Service Bulletin

No. : MZ02-032

Model: SR5200/SR6200/SR7200

Subject: Pop noise

* Version 1 P.C.Board (7020 06076 001-0) : Please apply the modification mentioned below (Page2 to 4).

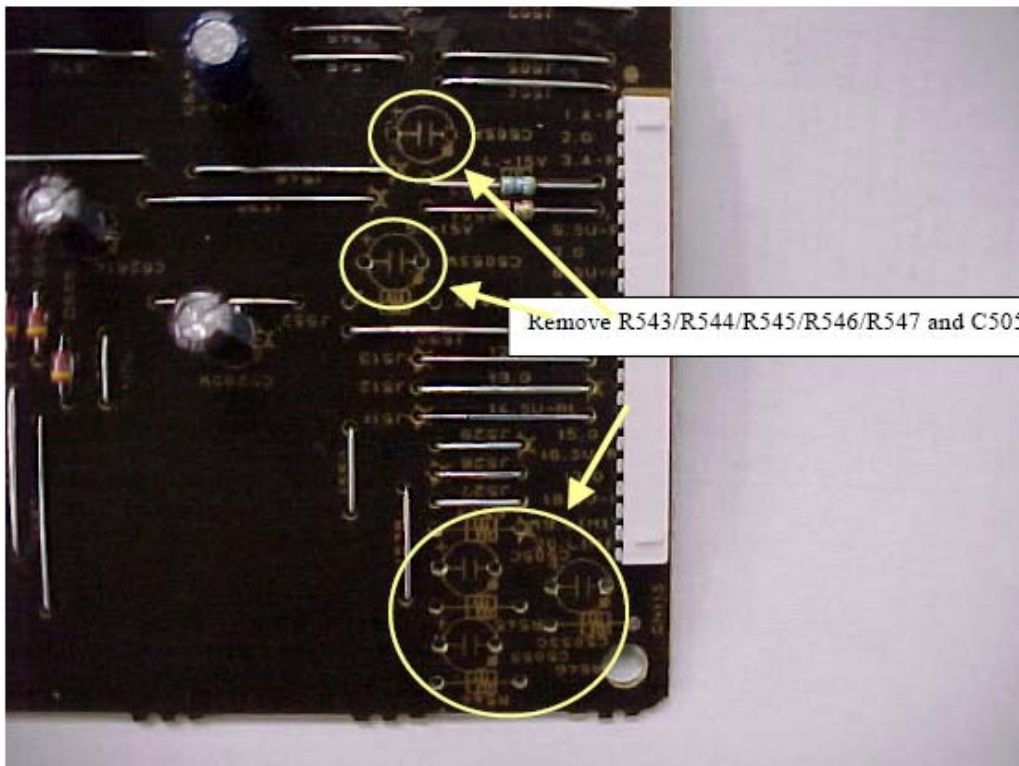
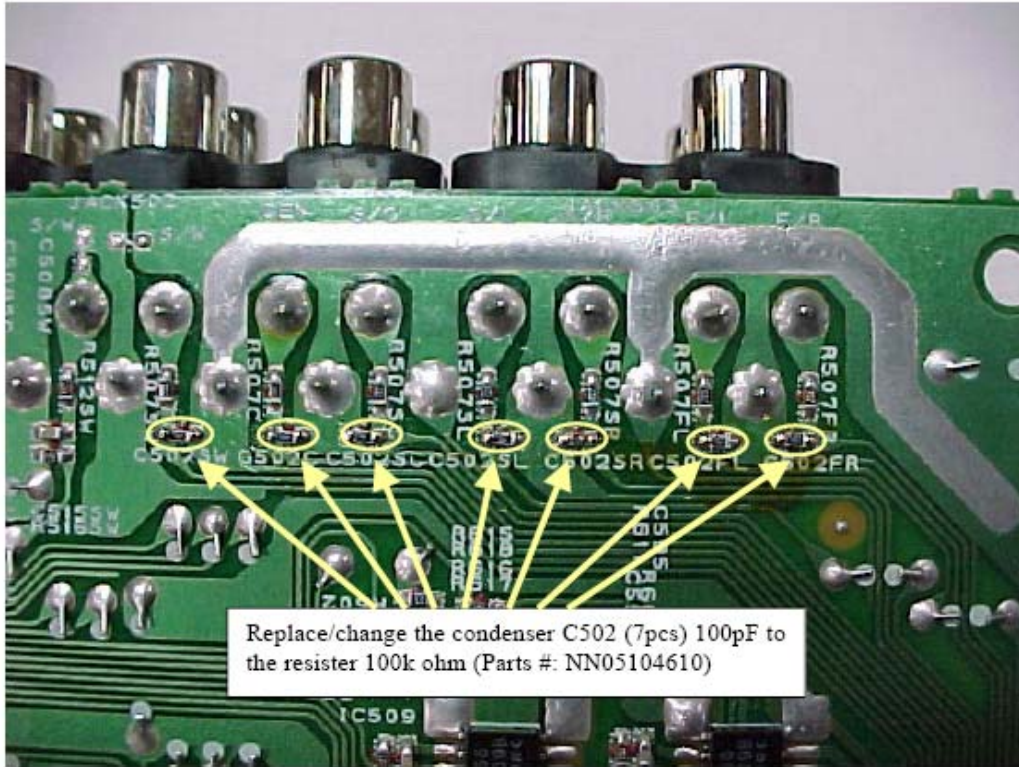
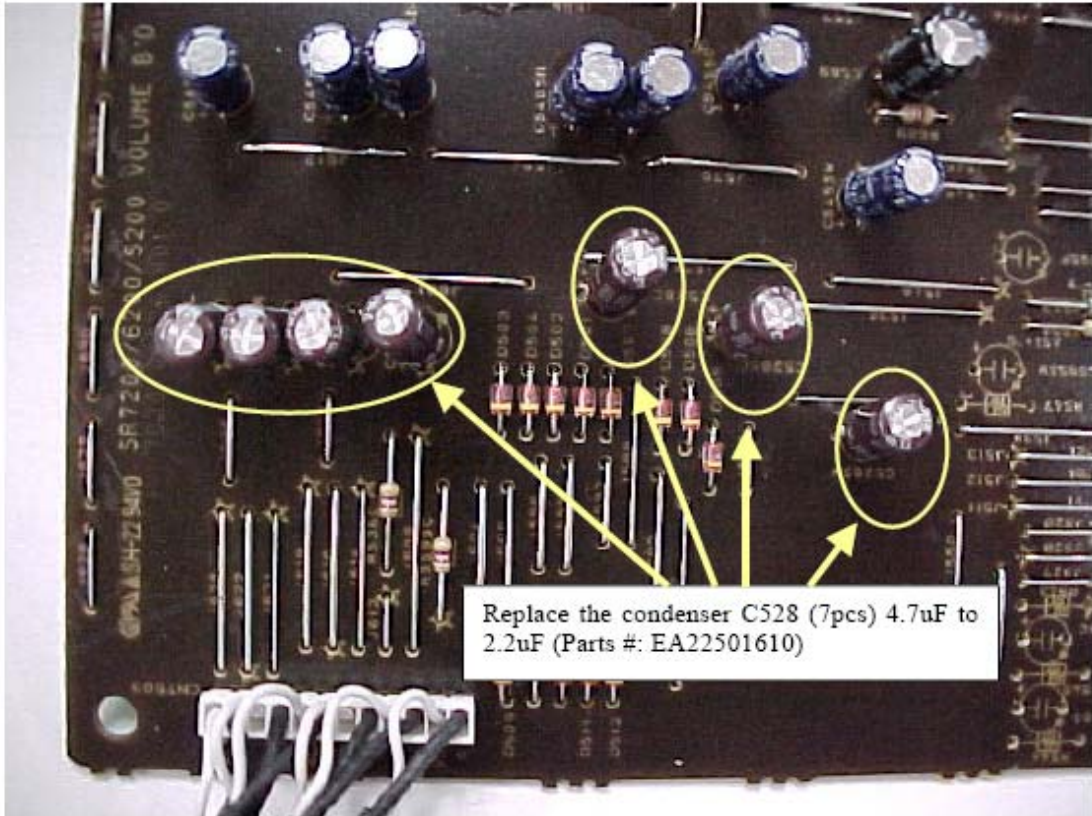
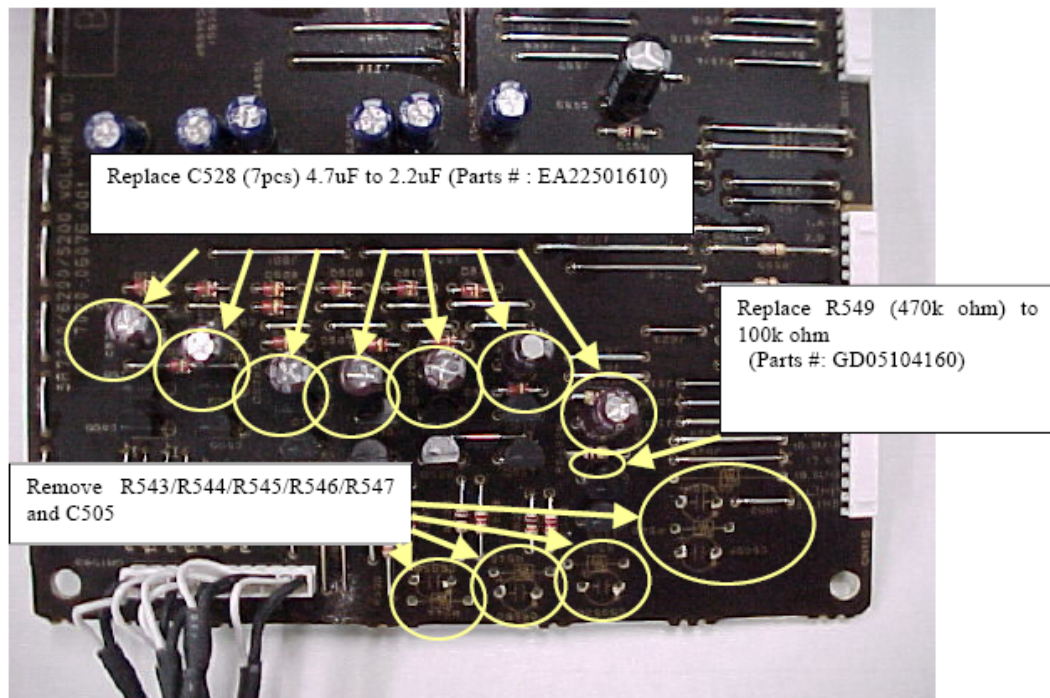
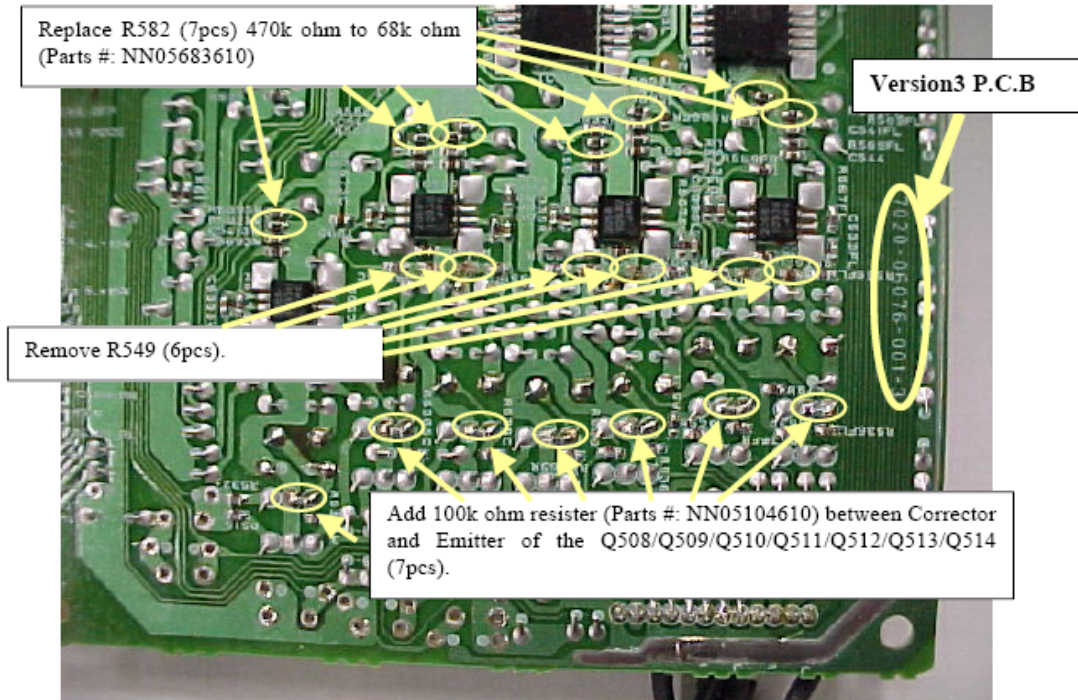
Symptom: A pop noise appears when you stop playing or skip tracks on CD playback when using a Digital connection. Pop noise appears when the Main volume is changed 74dB to 75dB (Mute).
